LaSalle County Station
2601 N. 21st Road
Marseilles, IL 61341-9757
Tel 815-357-6761

LaSalle County Station, Units 1 and 2
Facility Operating License Nos. NPF-11 and NPF-18
NRC Docket Nos. 50-373 and 50-374

Subject: Application for Amendment to Appendix A, Technical Specifications for the Oscillation Power Range Monitor Instrumentation

FIGURE 1

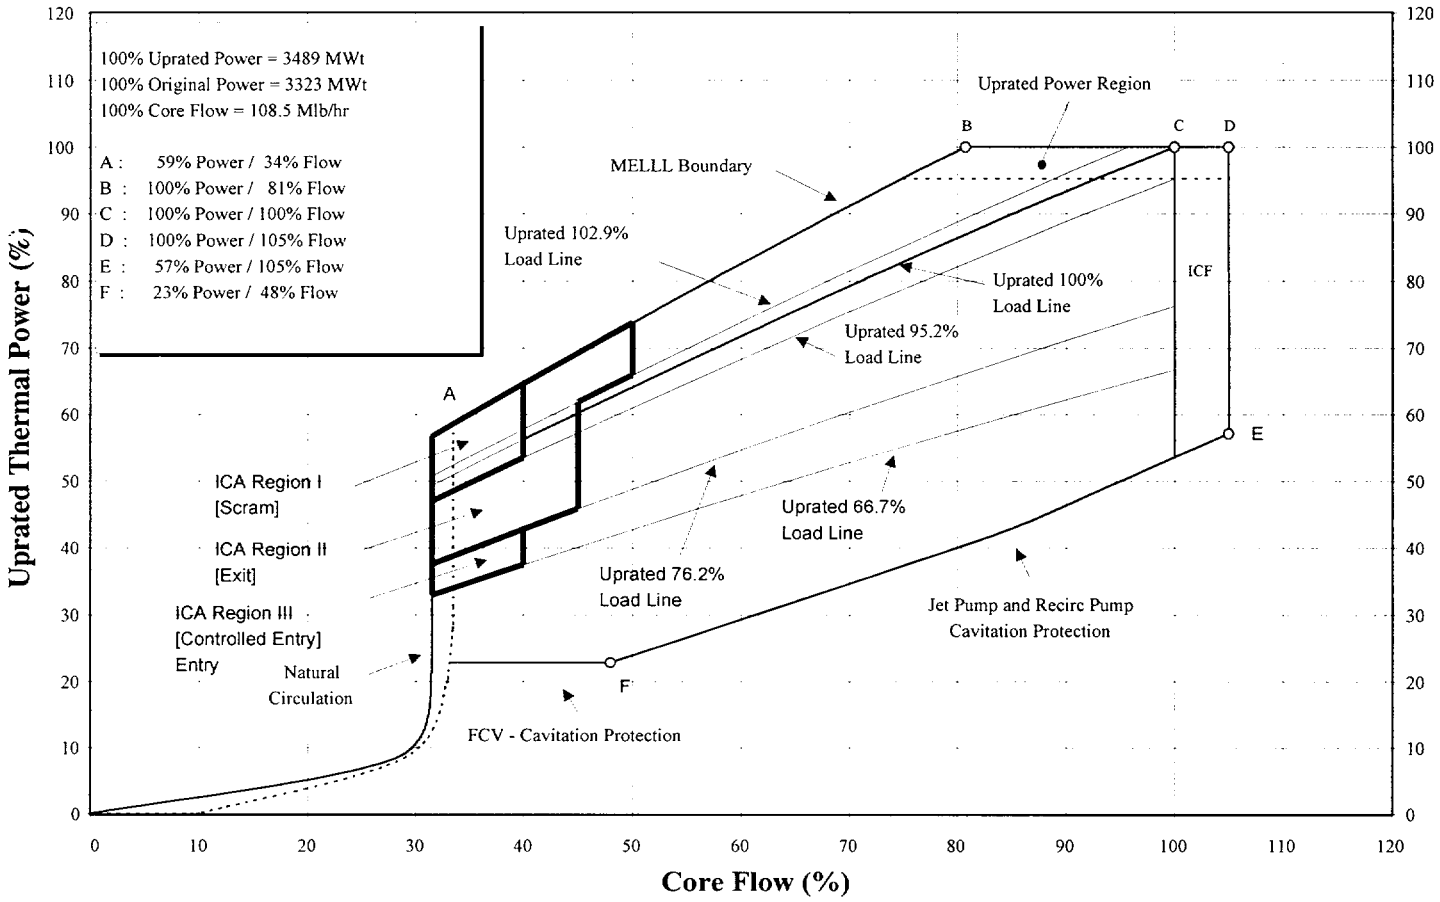
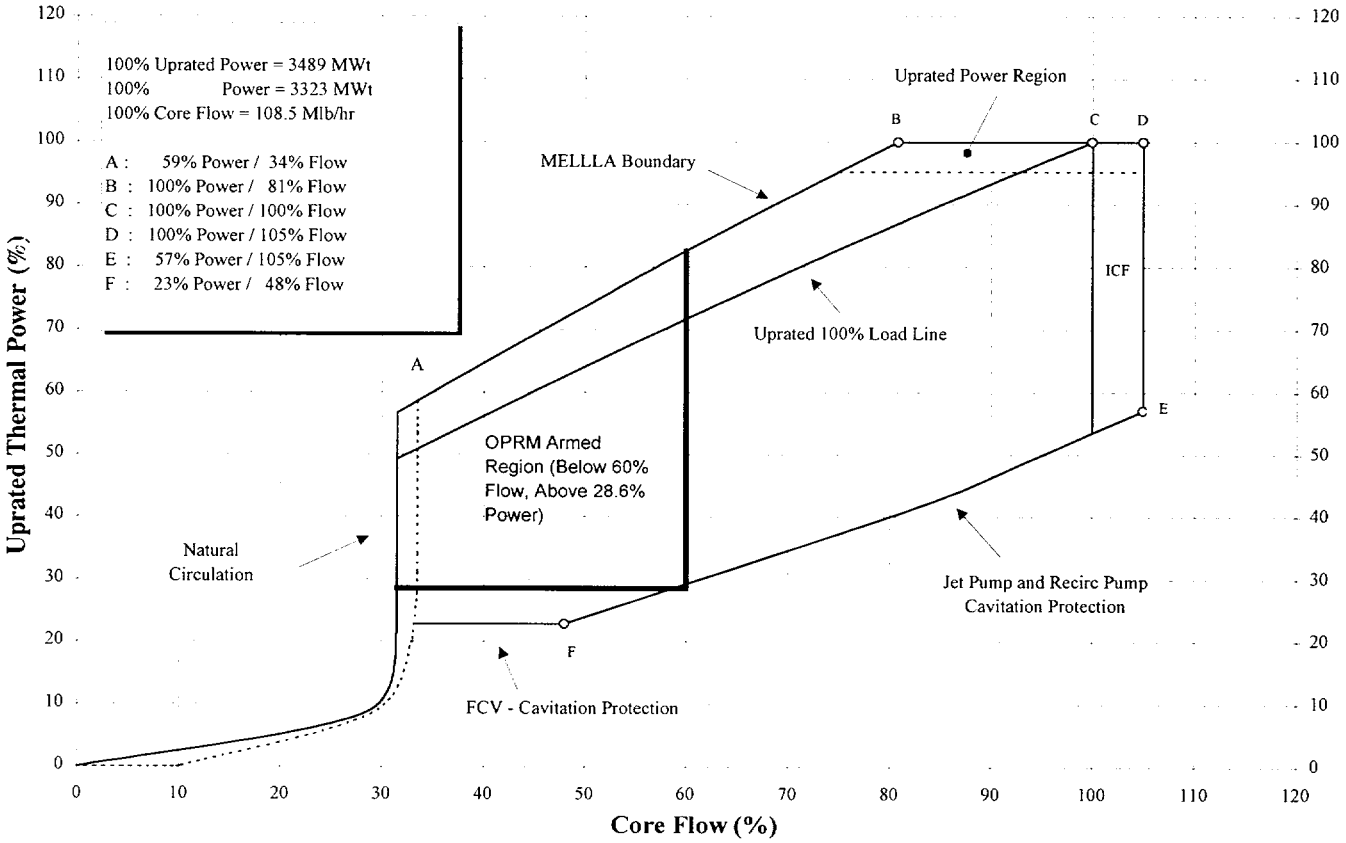
The OPRM Instrumentation trip enabled region of the Power/Flow Operating Map for Power Uprate was submitted by Reference (5) and approved by Reference (6) for LaSalle County Station Units 1 and 2 power uprate.

The proposed changes delete CTS Section 3/4.4.1.5 and the associated Power versus Flow Figure 3.4.1.5-1. References to Figure 3.4.1.5-1 are proposed to be deleted from the LaSalle County Station CTS Section 3.4.1.1 and the new OPRM Instrumentation TS are proposed to be incorporated into the CTS as Section 3/4.3.9. Additionally, a reference is added to Section 6.6.A.6, "Core Operating Limits Reports."

~~Figure 3.4.1.5-1~~

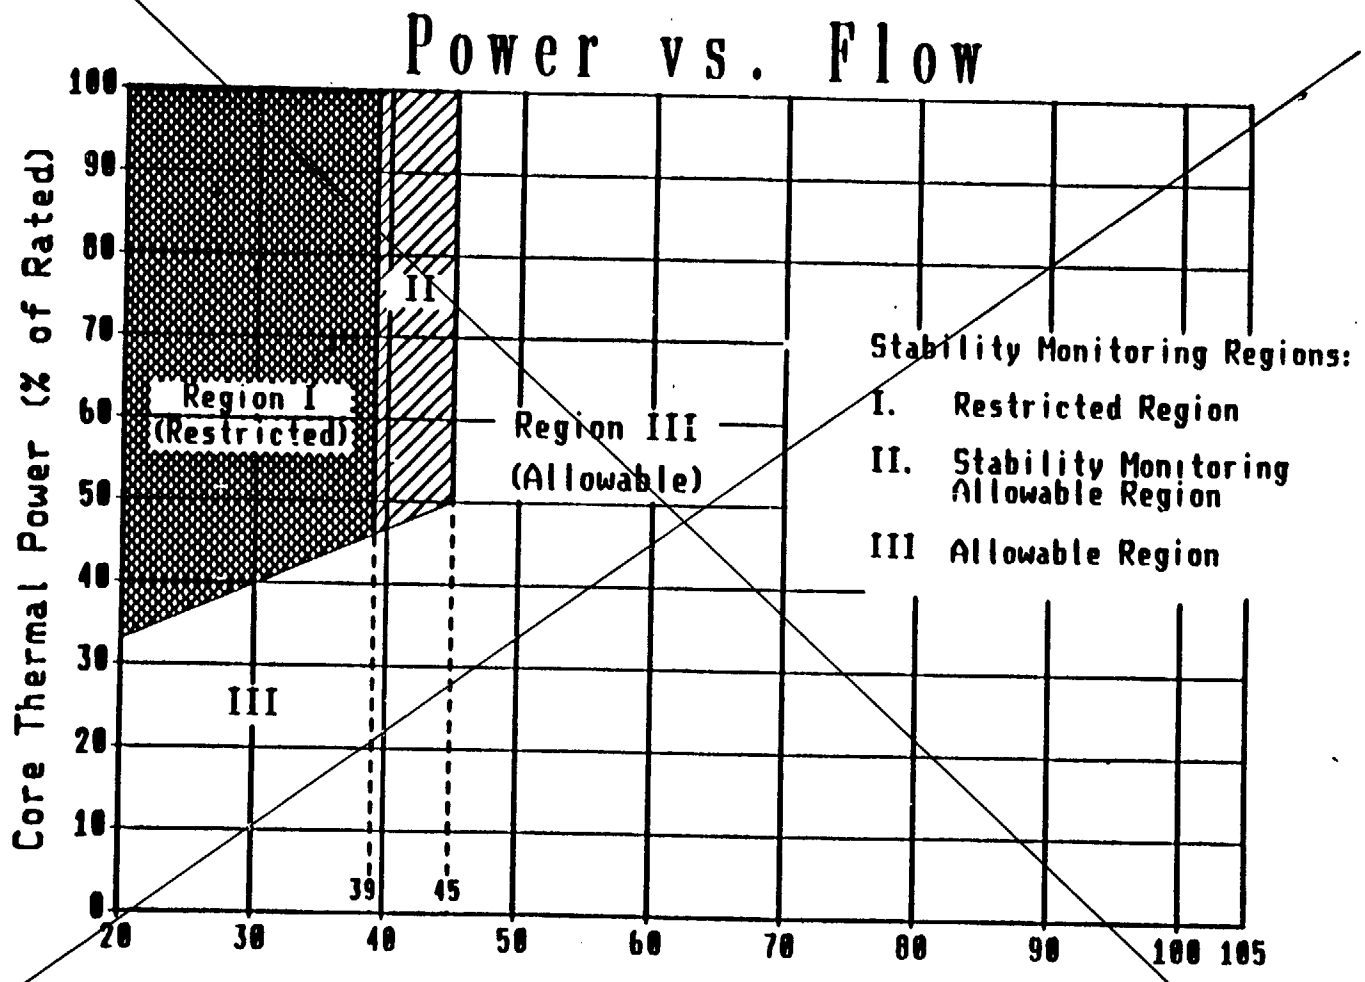
~~b. THERMAL POWER within Region III of Figure 3.4.1.5-1, or~~

~~c. THERMAL POWER within Region II of Figure 3.4.1.5-1 AND APRM and LPRM noise levels not exceeding the larger of: i) Three (3) times the established baseline noise levels or, ii) 10% peak-to-peak indicated noise level.~~

~~Figure 3.4.1.5-1~~

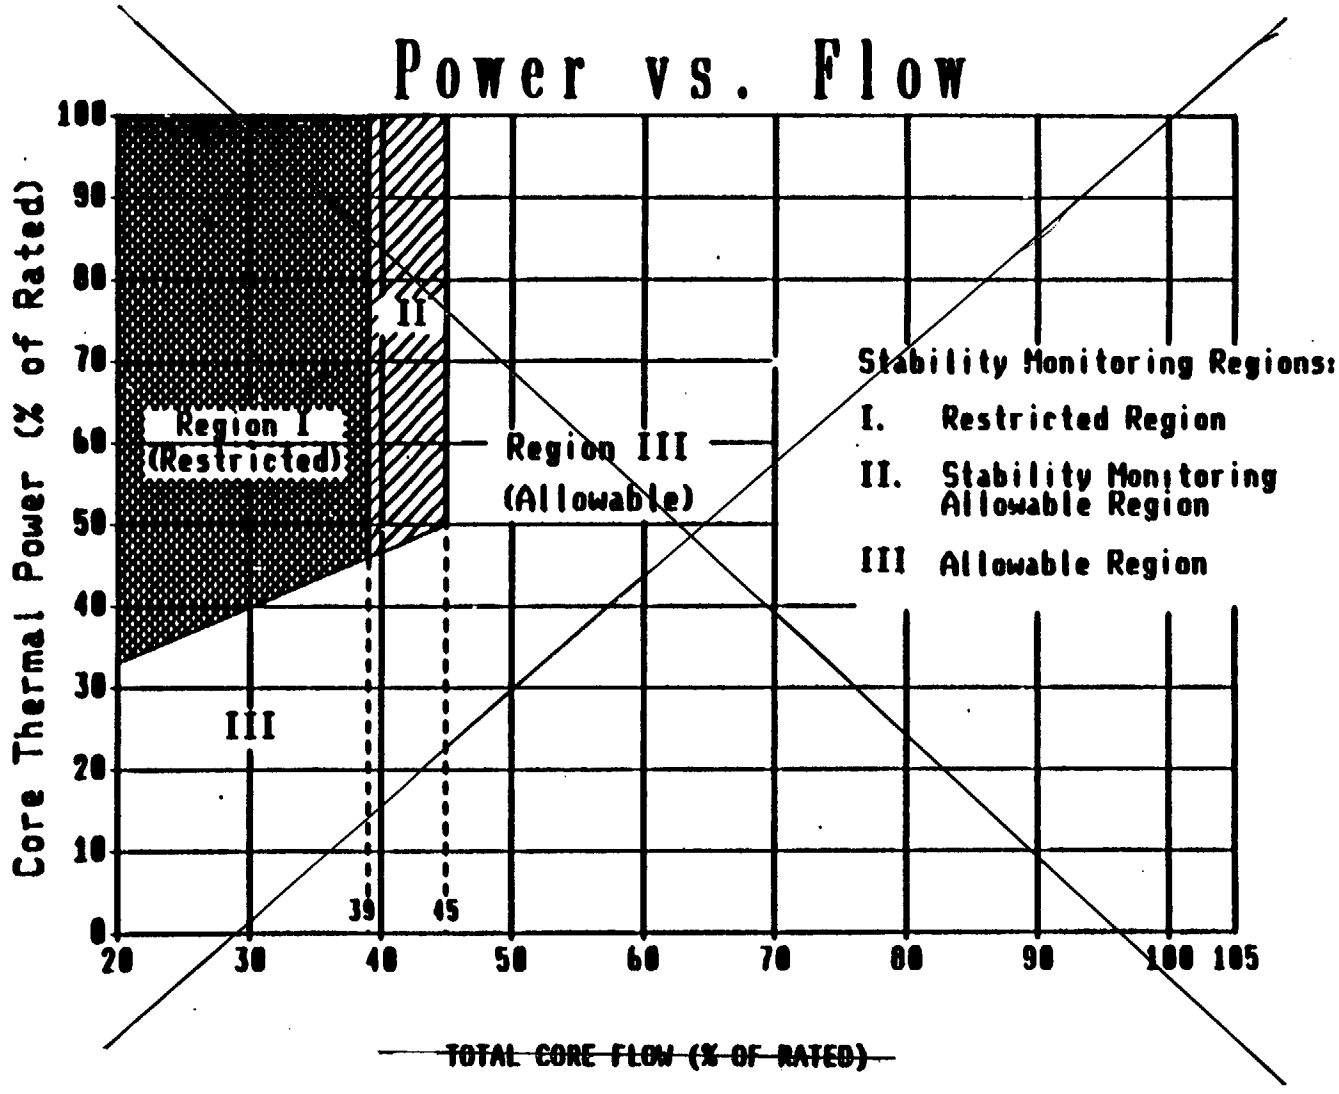
~~b. THERMAL POWER within Region III of Figure 3.4.1.5-1, or~~

~~c. THERMAL POWER within Region II of Figure 3.4.1.5-1 AND APRM and LPRM noise levels not exceeding the larger of: i) Three (3) times the established baseline noise levels or, ii) 10% peak-to-peak indicated noise level.~~

~~Figure 3.4.1-1 (Page 1 of 1)~~
~~Power versus Flow~~

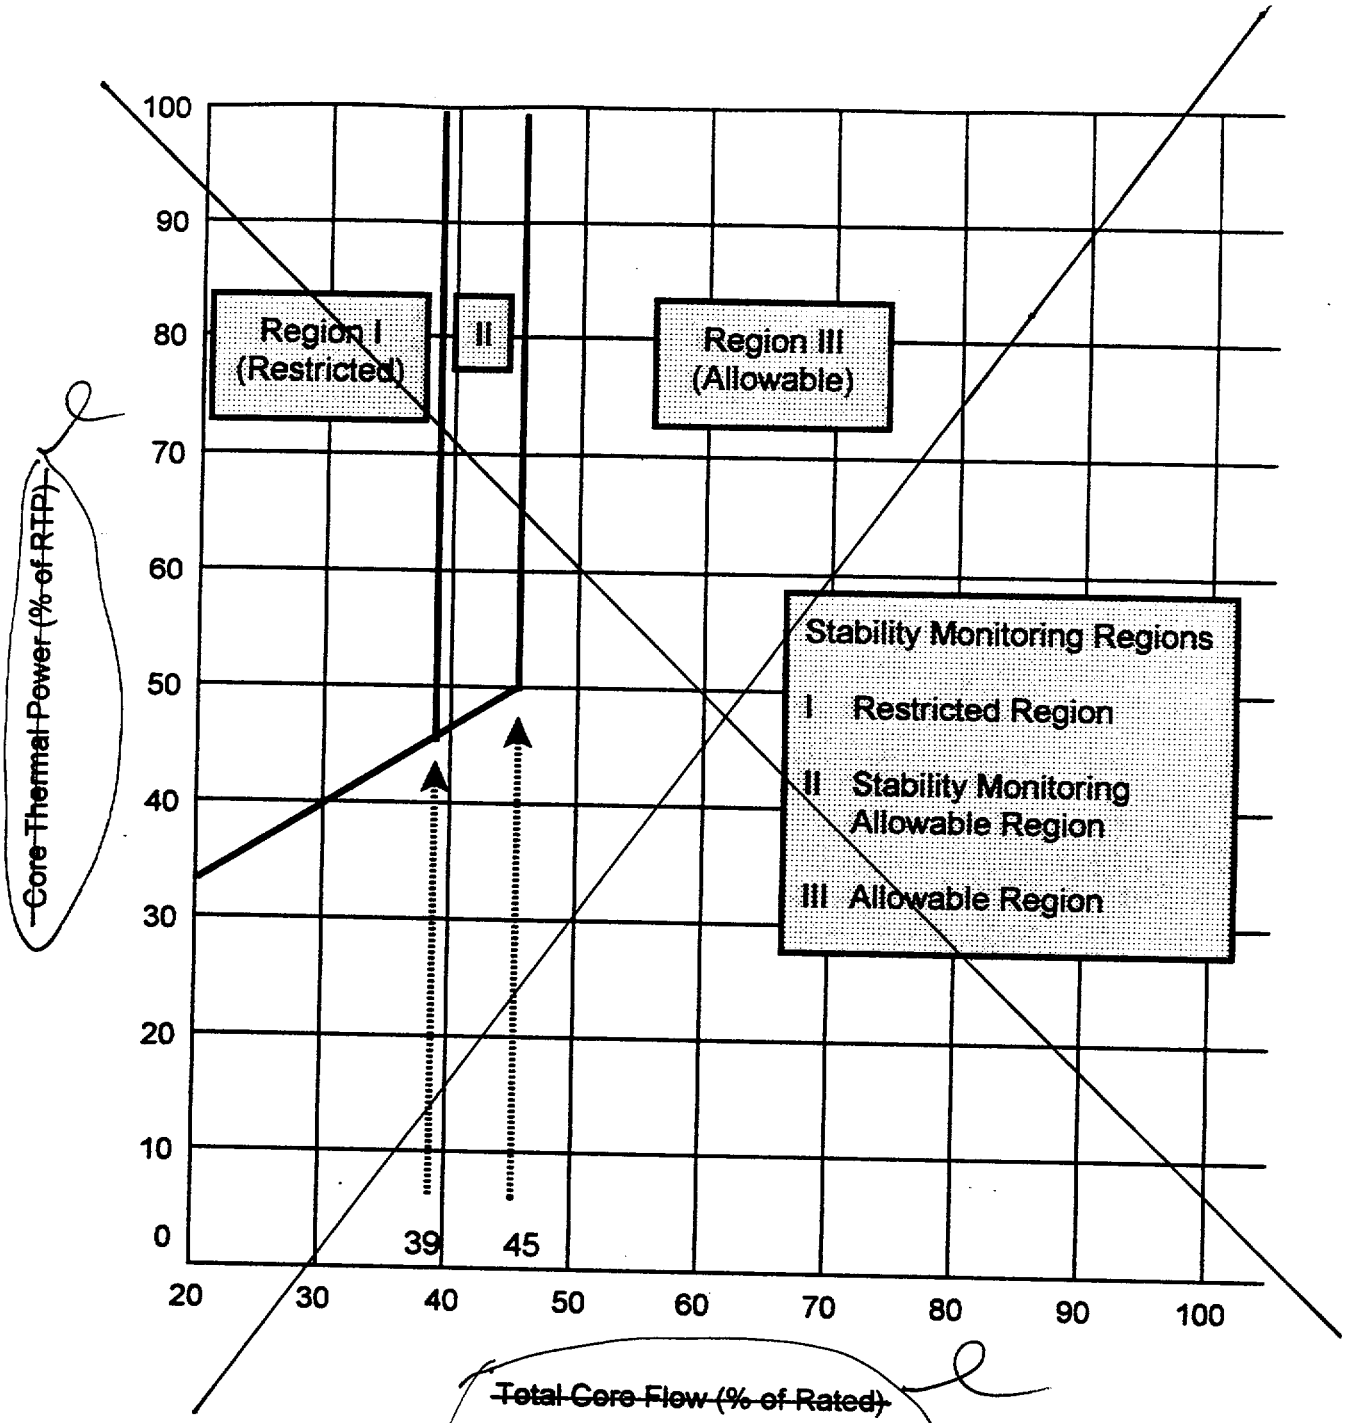
1. Delete ITS Power versus Flow Figure 3.4.1-1 and associated references to the figure from ITS Section 3.4.1," Limiting Condition for Operation (LCO), Actions, and Surveillance Requirements (SRs).
2. Add ITS Section 3.3.1.3, "Oscillation Power Range Monitor (OPRM) Instrumentation" and add a reference to Section 5.6.5, "Core Operating Limits Report (COLR)".

LCO 3.4.1 Two recirculation loops with matched flows shall be in operation ~~within Region III of Figure 3.4.1-1~~.

One recirculation loop shall be in operation ~~within Region III of Figure 3.4.1-1~~ with the following limits applied when the associated LCO is applicable:
